Subject: Braidwood Station Unit 1  
NRC Docket Number 50-456

Response to Request for Additional Information Pertaining to Operating Interval  
Between Eddy Current Inspections for Circumferential Indications in the  
Braidwood Unit 1 Steam Generators

**Figure 8a: Burst Pressure vs. Maximum ECT Amplitude**  
(Commonwealth Edison Data, LTL Flow Stress)

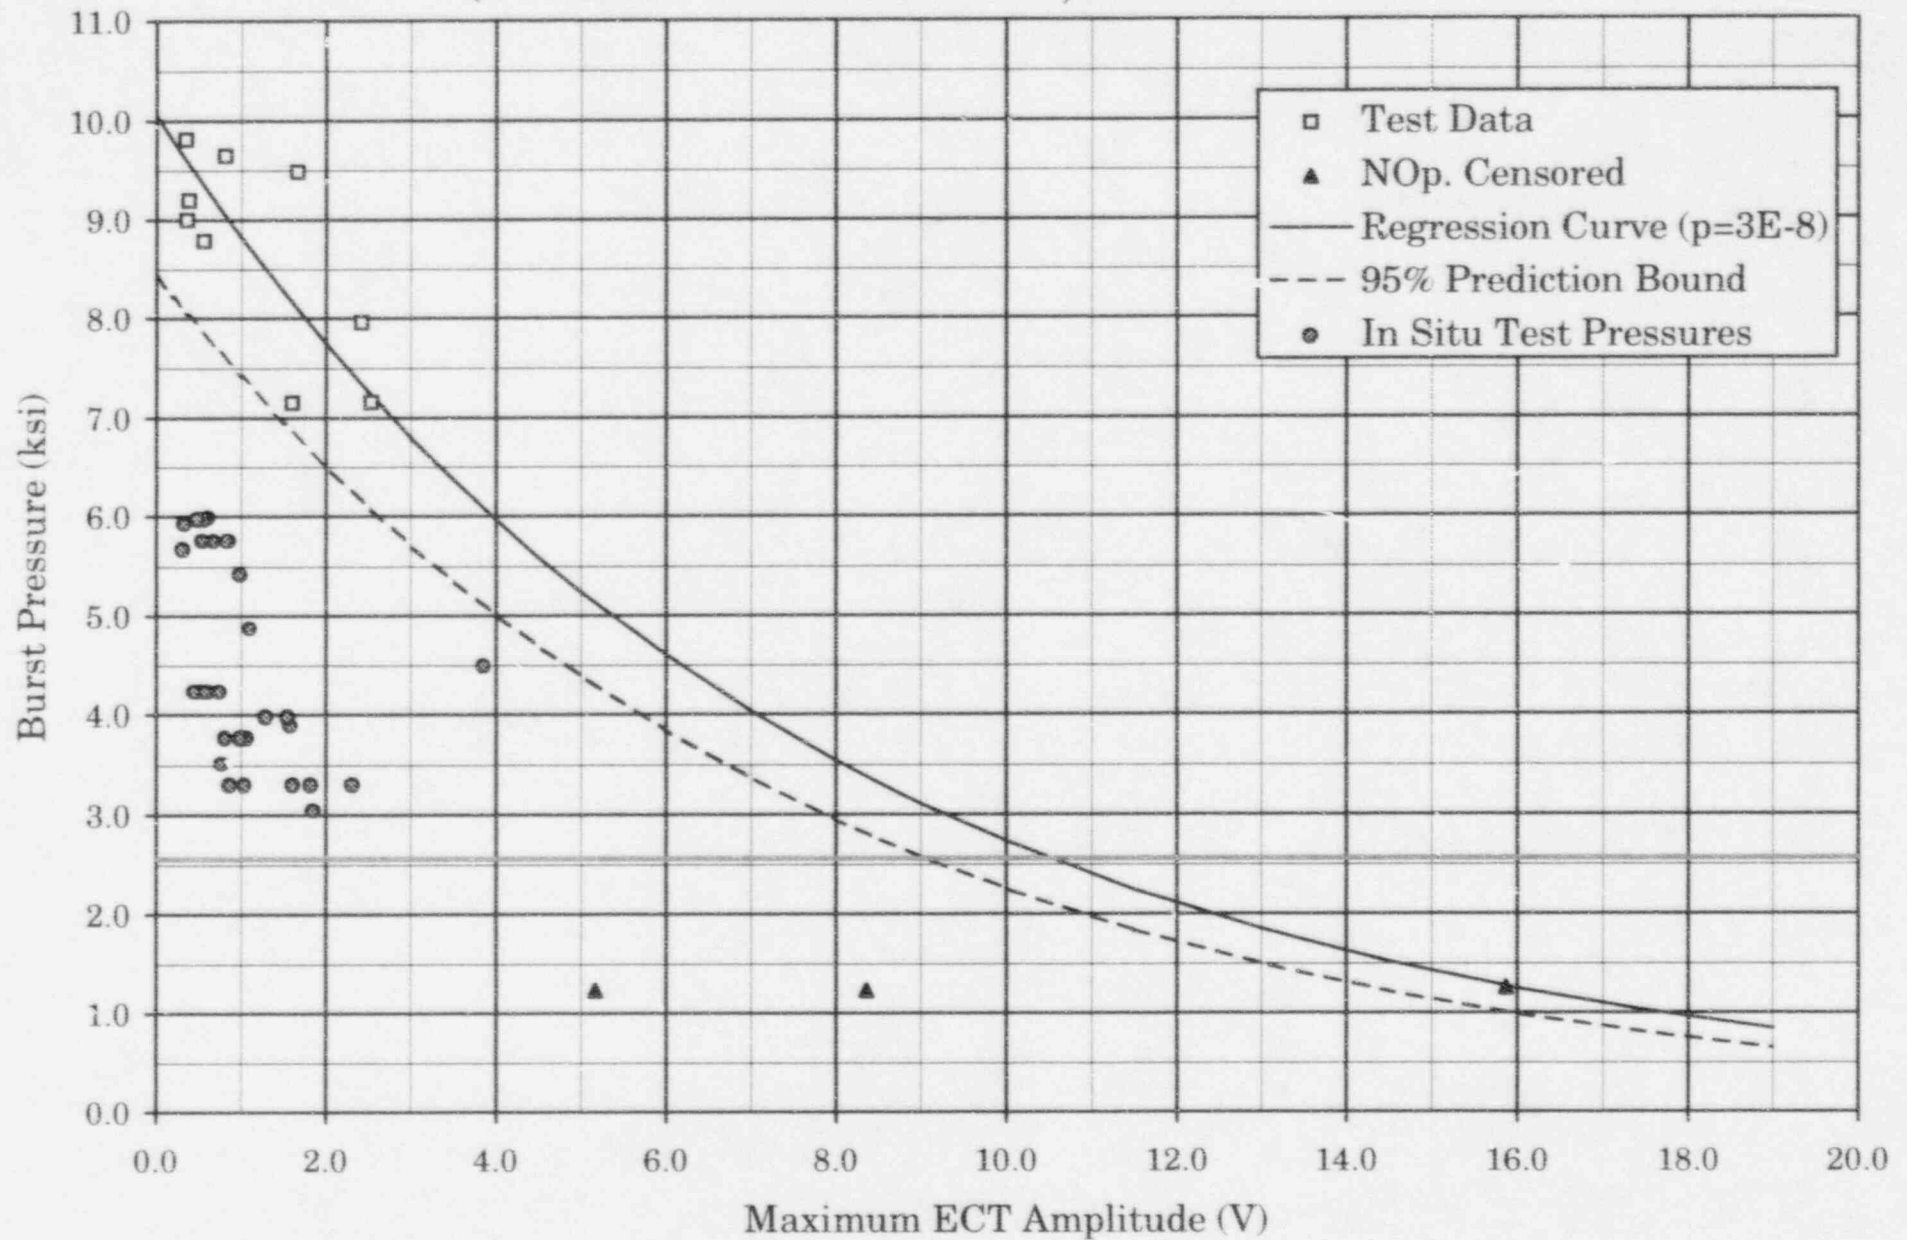
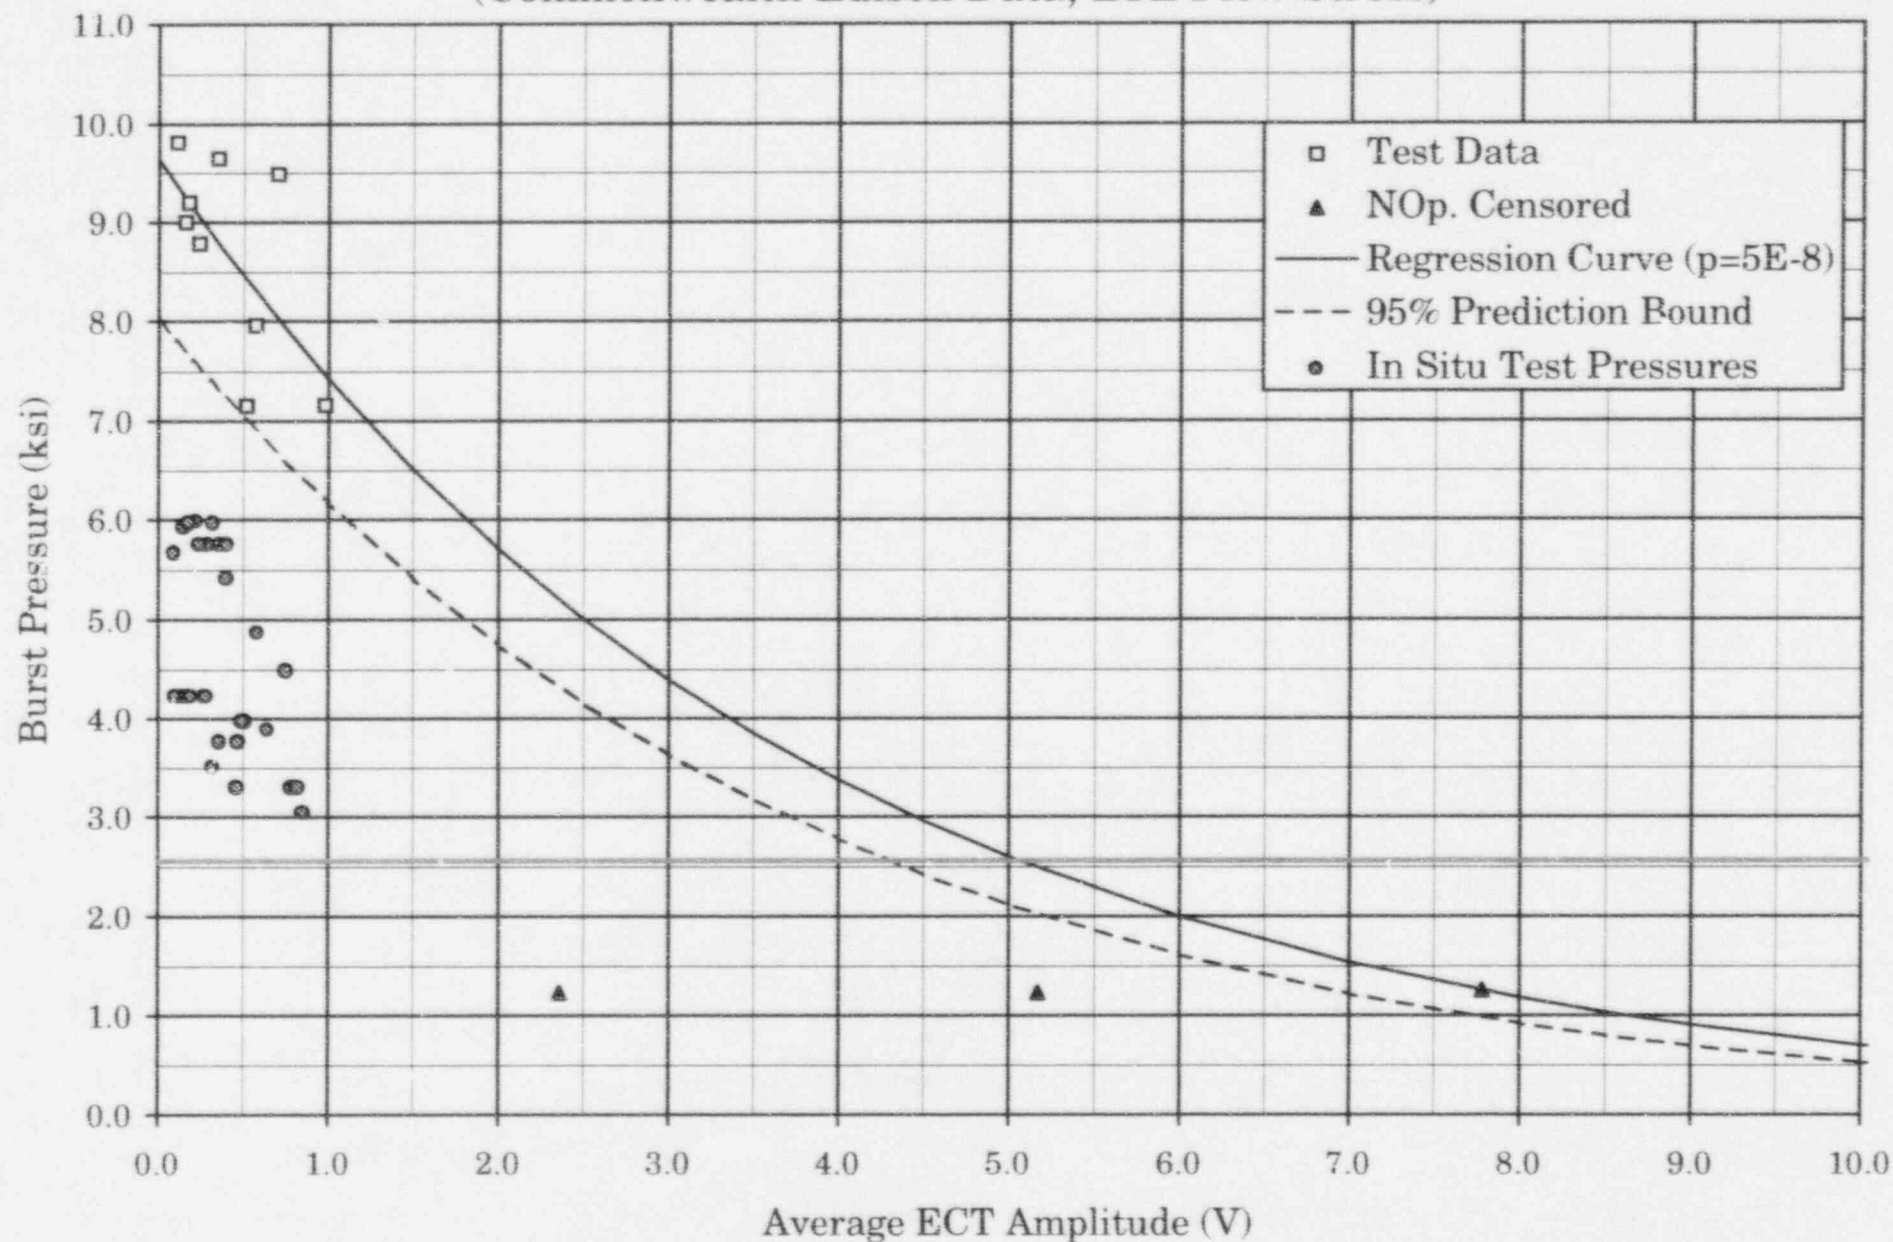
- 8. Provide the basis for the shape of the curve used to determine the lower bound SG tube burst pressure. Determine whether a statistical fit to the data can be established using the available data set; i.e., the statistical fit should be valid at the 5% level consistent with GL 95-05. The guidance provided in GL 95-05 with respect to empirical models should be addressed; e.g., provide the order of the regression equation. If a statistical fit to the data can be established, provide a detailed probabilistic analysis of the conditional burst probability which is consistent with the intent of GL 95-05.**

both maximum and average voltages. The results from the statistical evaluation, including the mean regression line, and the 95% prediction bound curve are presented in Figures 8a and 8b for maximum and average voltage, respectively. Review of Figures 8a and 8b indicates that the burst pressure trends to zero at voltages less than those observed in service, as indicated by the insitu tests and the three non burst tested tubes (no failure at normal operating pressure) with the highest voltages (see the data provided in the response to Question #5). Therefore, the linear regression fit does not realistically model the service and burst data.

Figure 5.5

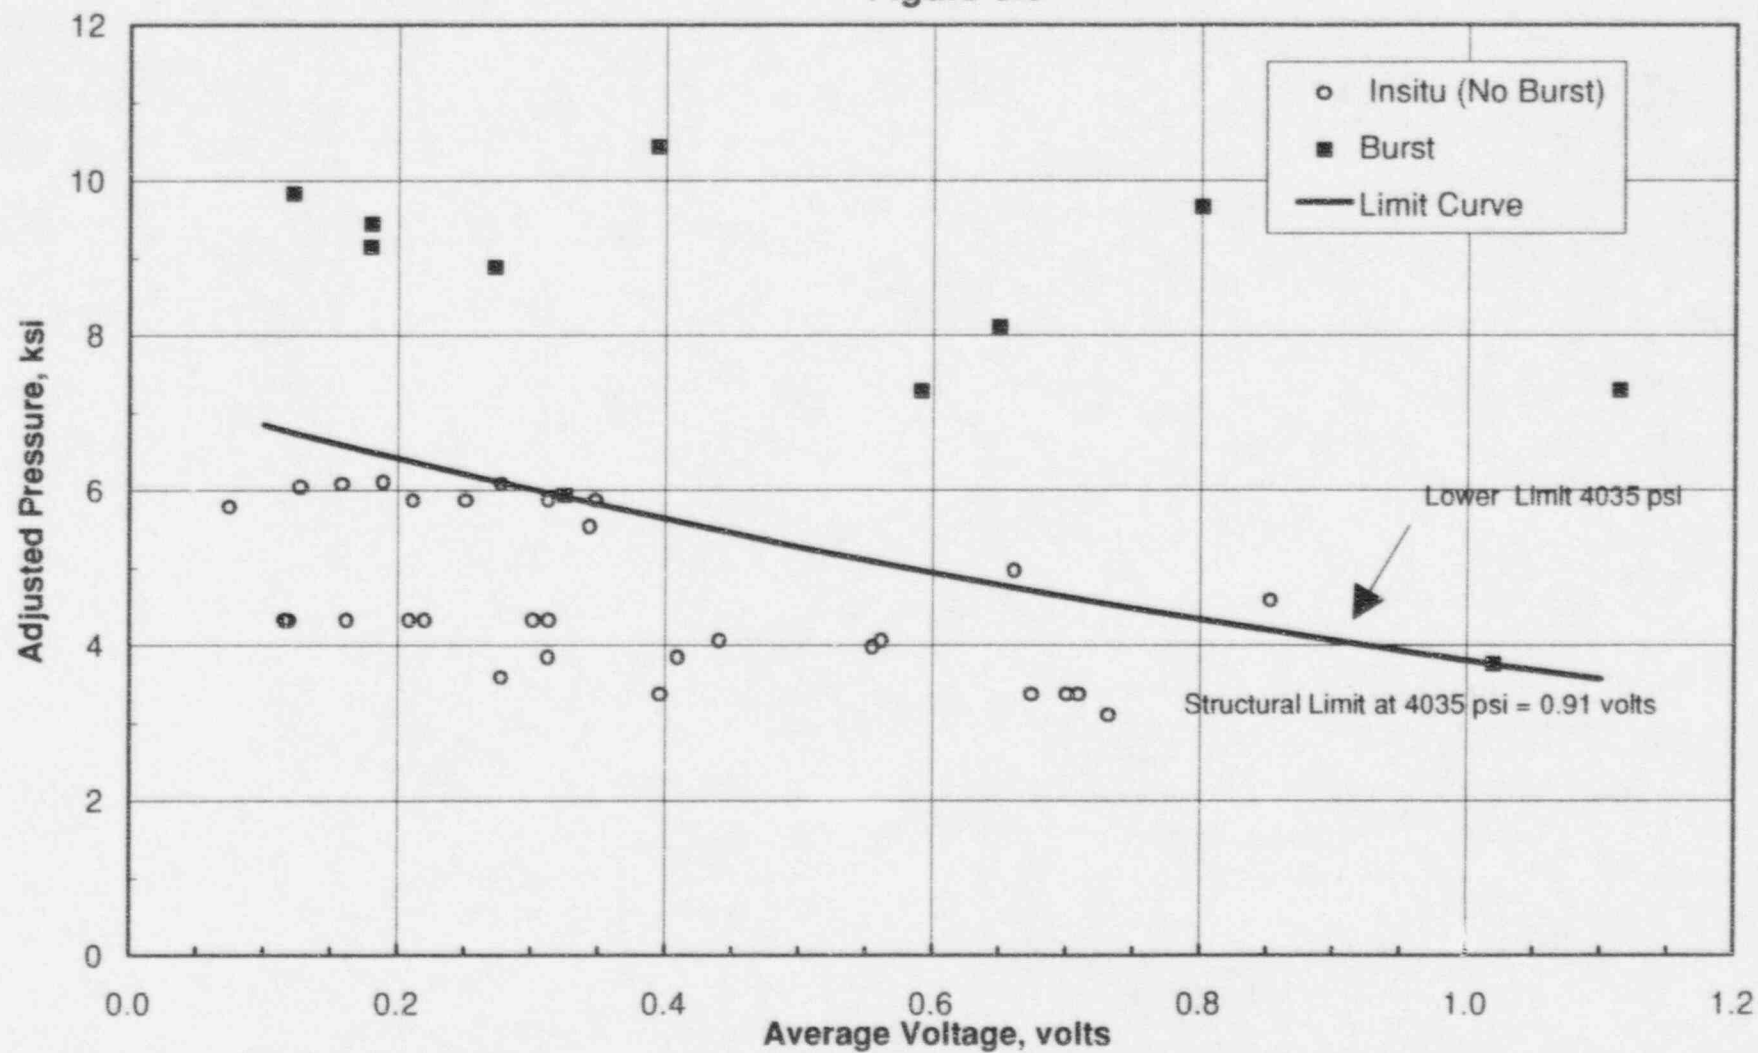
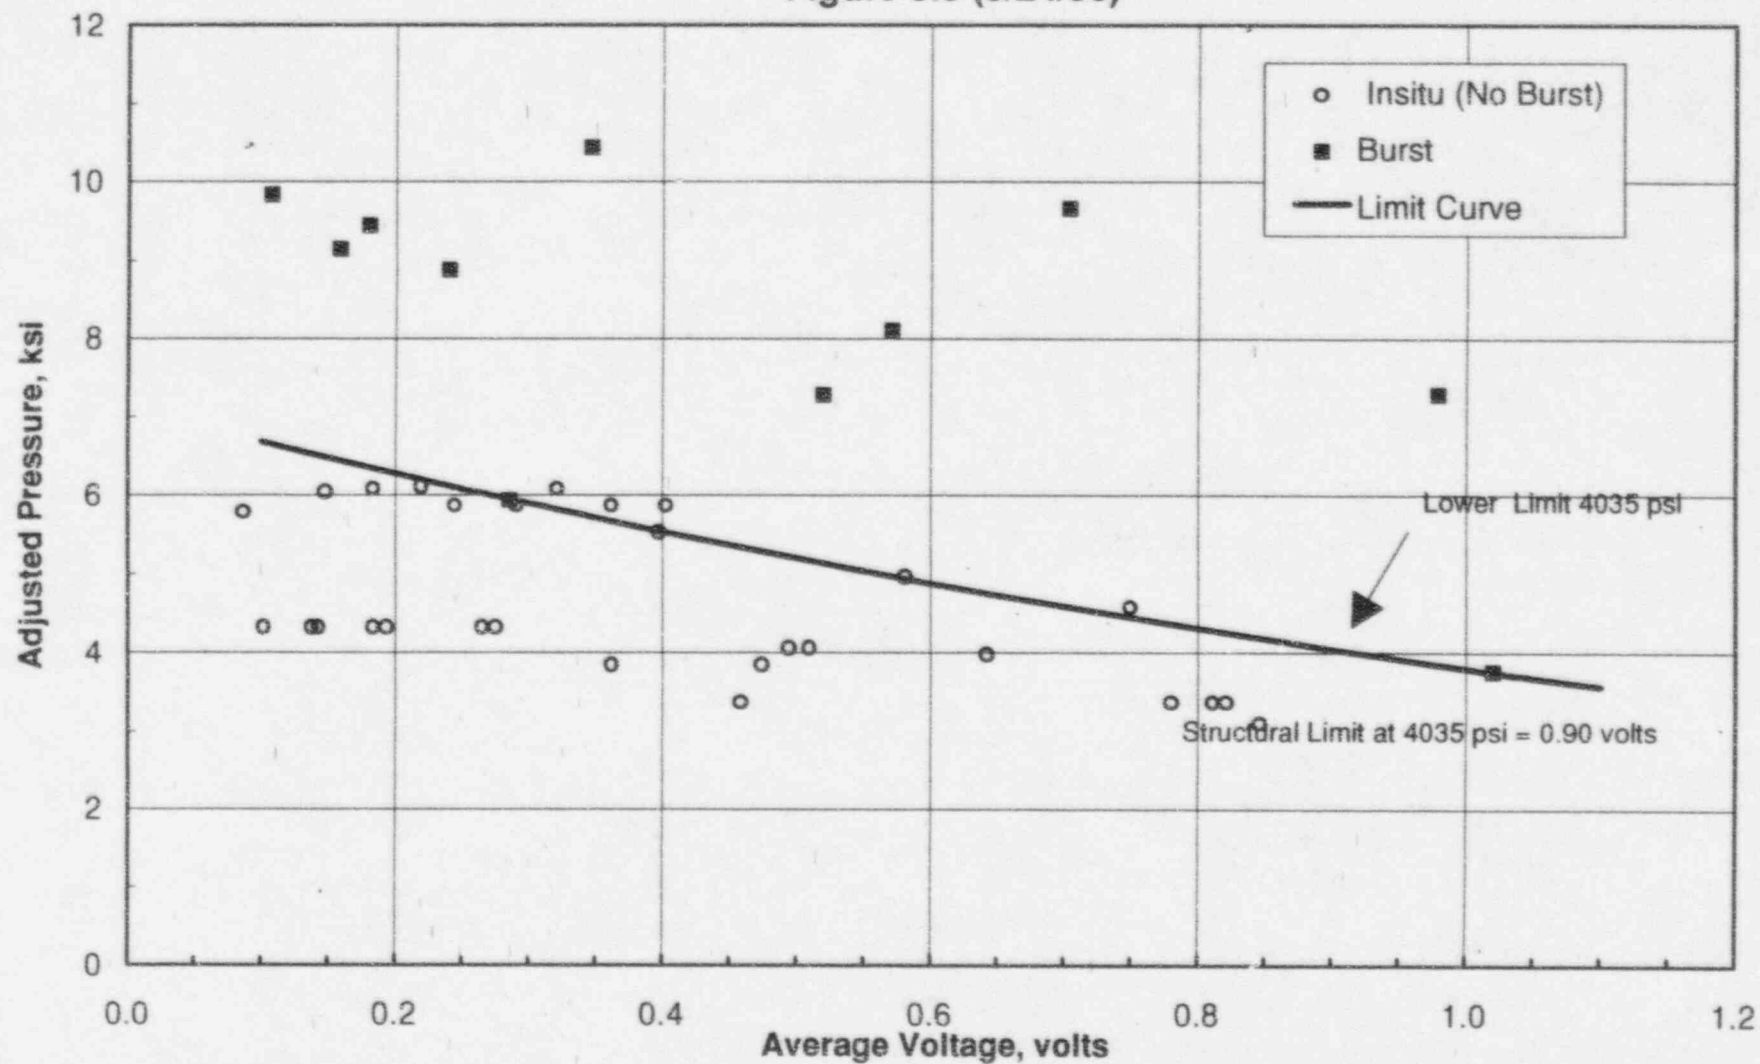
1. August 2, 1996, Submittal, Figure 5.5, 5.6 and 6.1 do not include one insitu pressure test point. Data for this test was acquired subsequent to the submittal and therefore it was not included in the figures. The point is located at 0.67 max Volts and 0.28 avg. Volts corresponding to a corrected test pressure of 3.577 ksi.

This additional point has been included in all analyses. The additional data point does not change the results or conclusions of the report. Additionally, the axes on Figure 6.1 were incorrectly labeled in the August 2, 1996 submittal. The updated Figures 5.5, 5.6 and 6.1 are attached.
